LOUISIANA
POWER & LIGHT

W3K84-0974
3-A1.01.04

SUBJECT: Waterford 3 Steam Electric Station
Docket No. 50-382
Construction Adequacy of WSES-3 Basemat

Attached are our responses to the questions. There are only minor changes, mostly of an editorial nature or in response to comments from the NRC staff.

CLIENT LOUISIANA POWER & LIGHT COMPANY

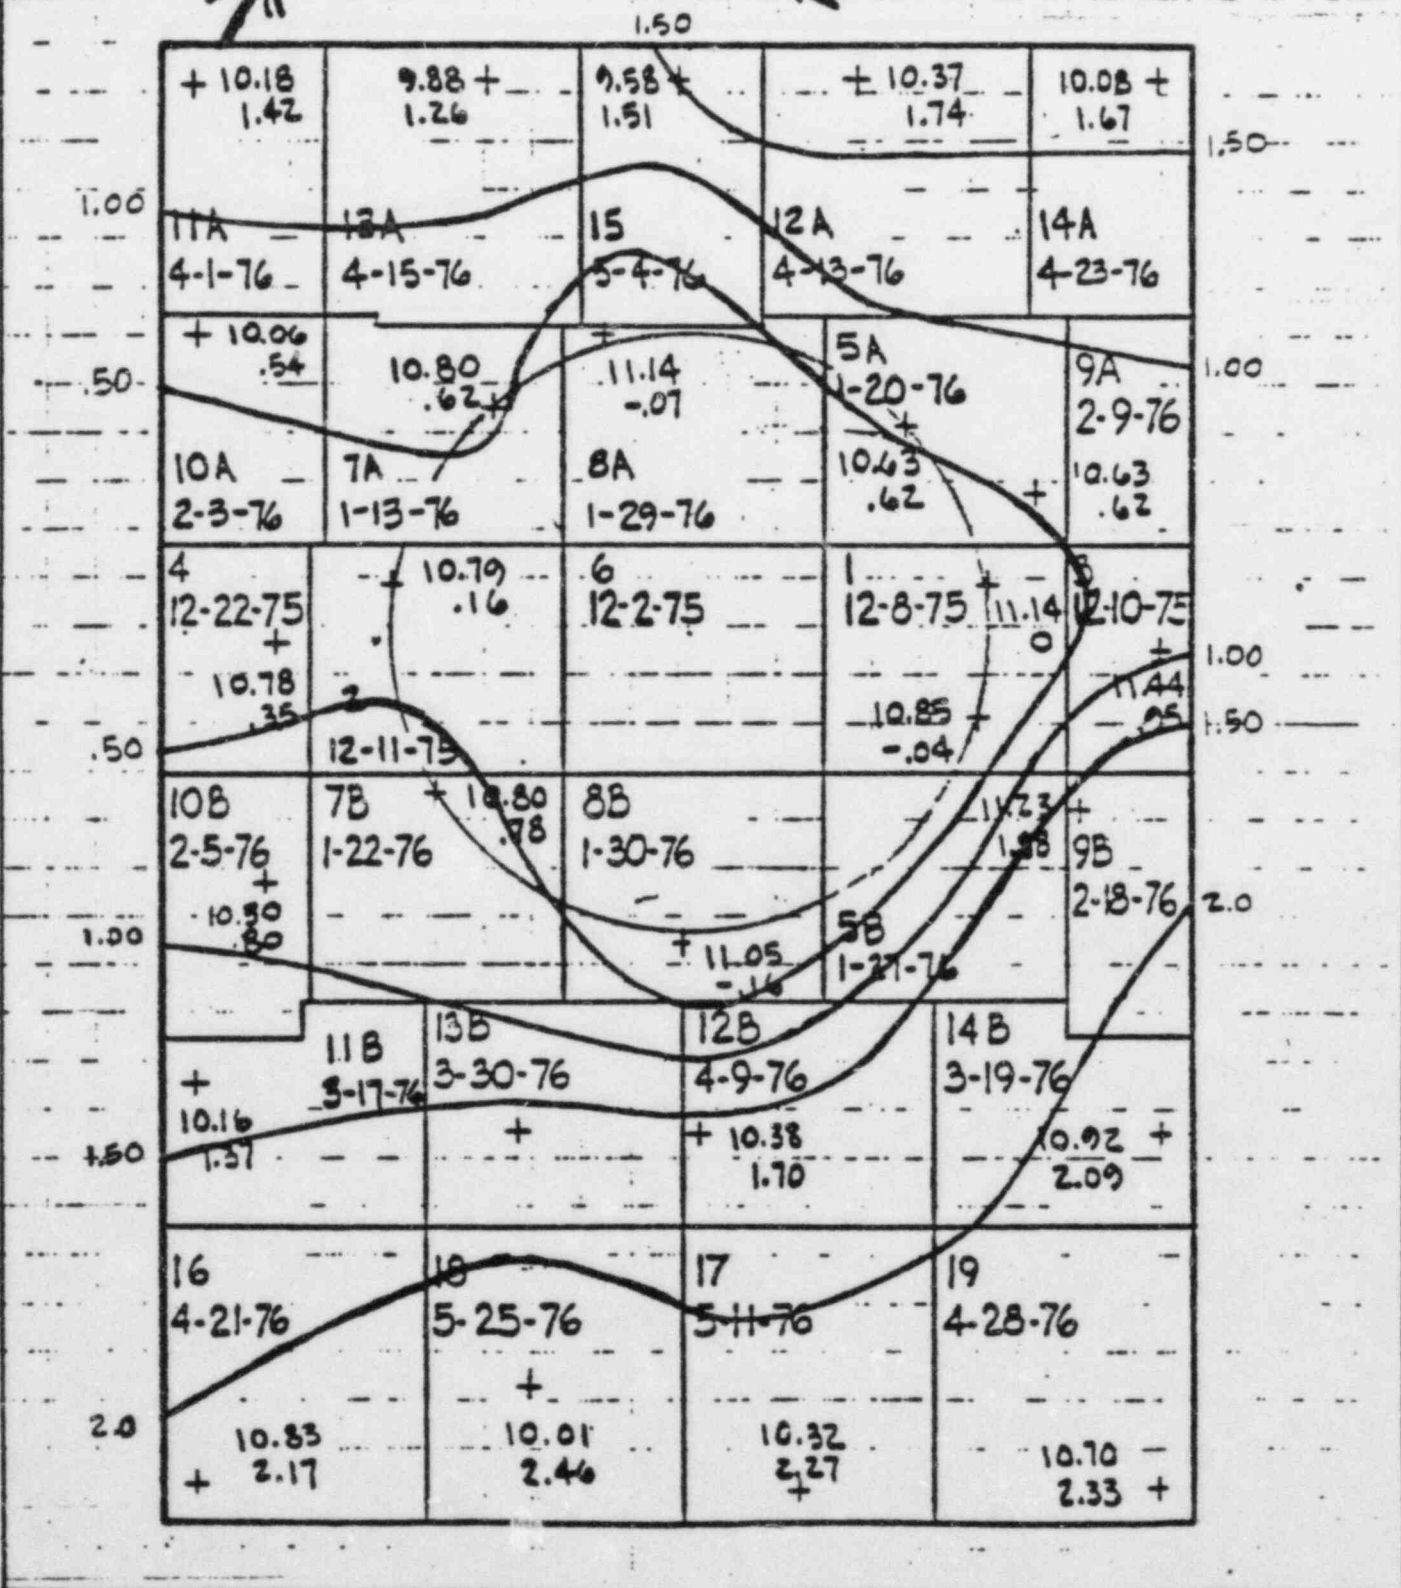
17. Provide differential settlement contours for 6 month periods, starting from early 1977 to present.
